Arlington Zoning Board of Appeals

Thorndike Place - Proposed Draft Decision

DECISION ON APPLICATION FOR COMPREHENSIVE PERMIT

G.L. c. 40B, §§ 20-23

DWG.:	SHEET C-203
JOB. NO: 23407.00

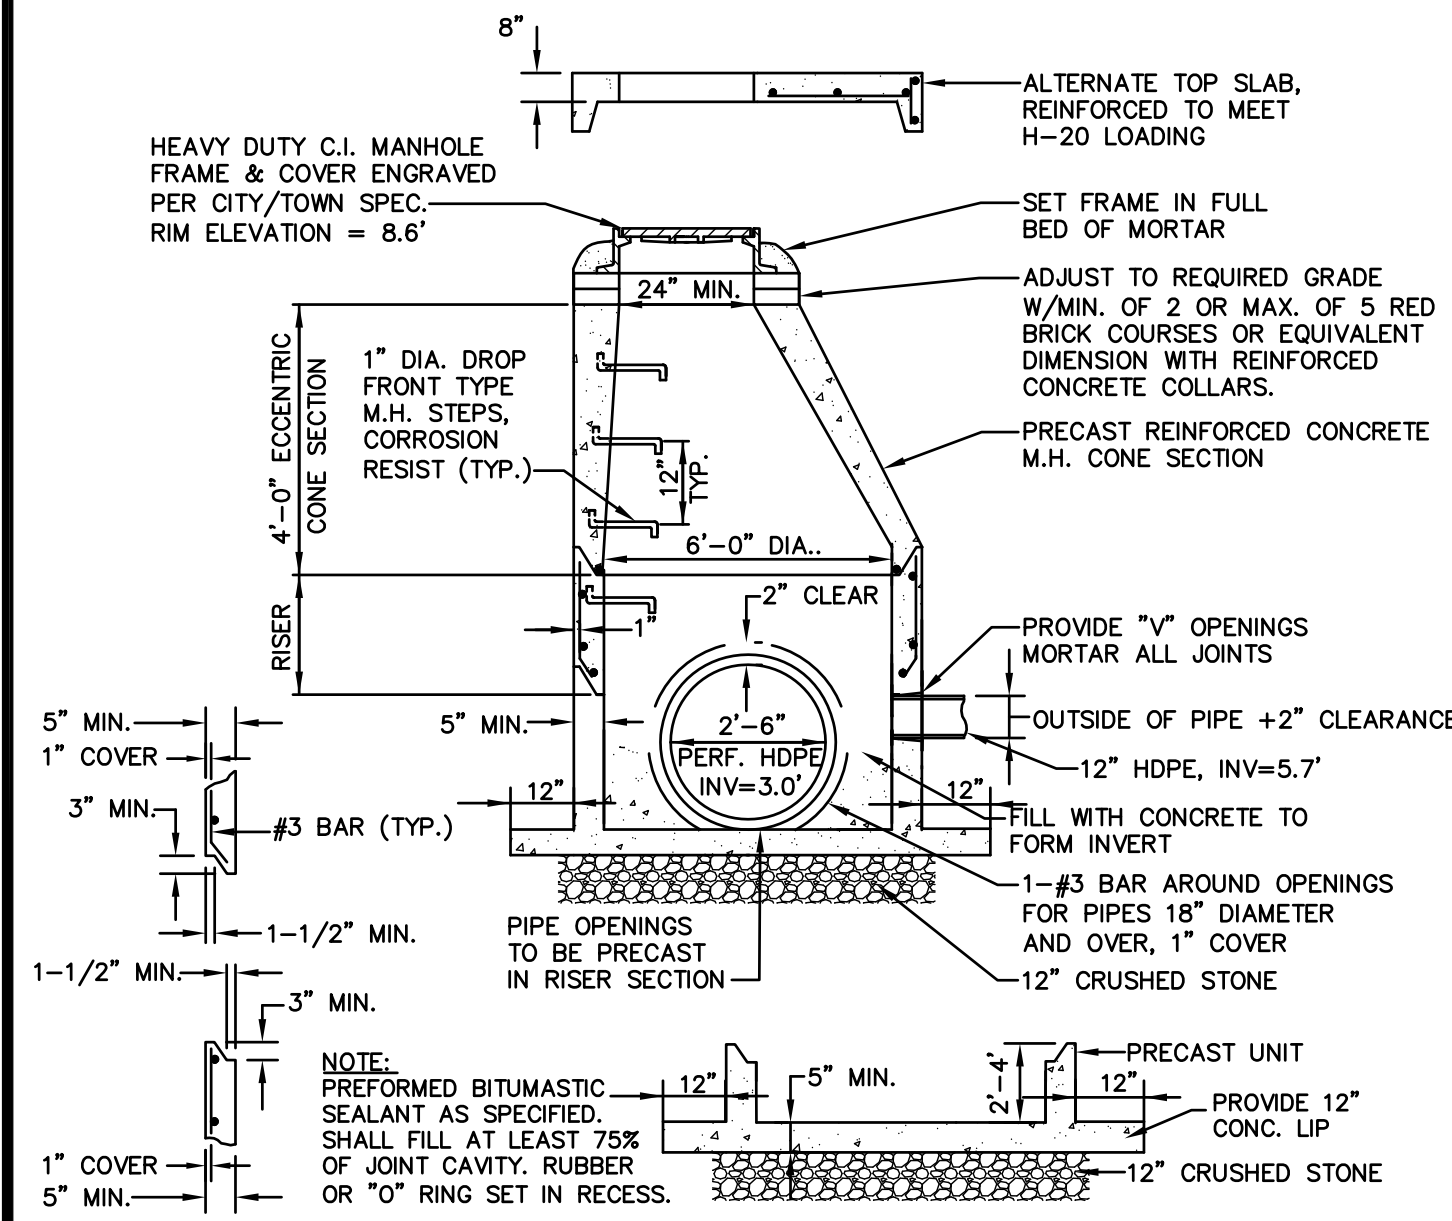
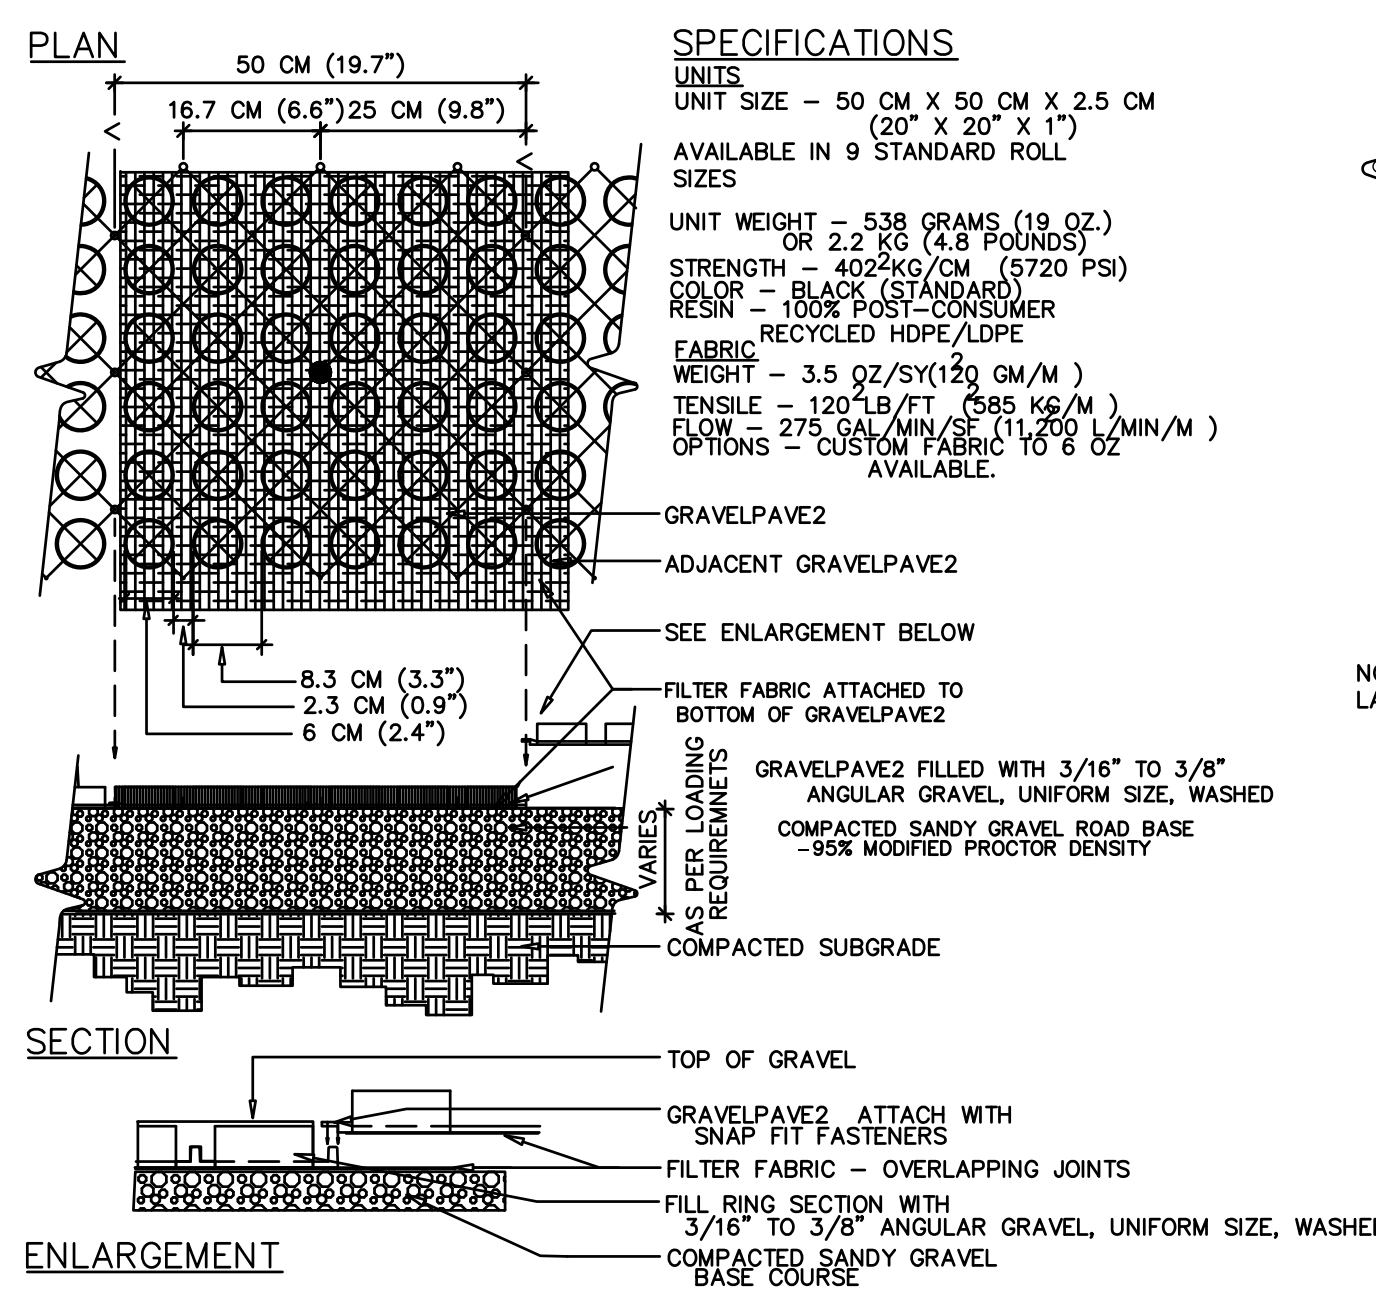
- j. The Final Plans shall include the detail of the Outlet Control Structure shown on Sheet C-203 to be revised to more accurately depict that the invert of the 12" outlet pipe is at the top of the 30" inlet and to show the installation of the proposed backflow preventer.
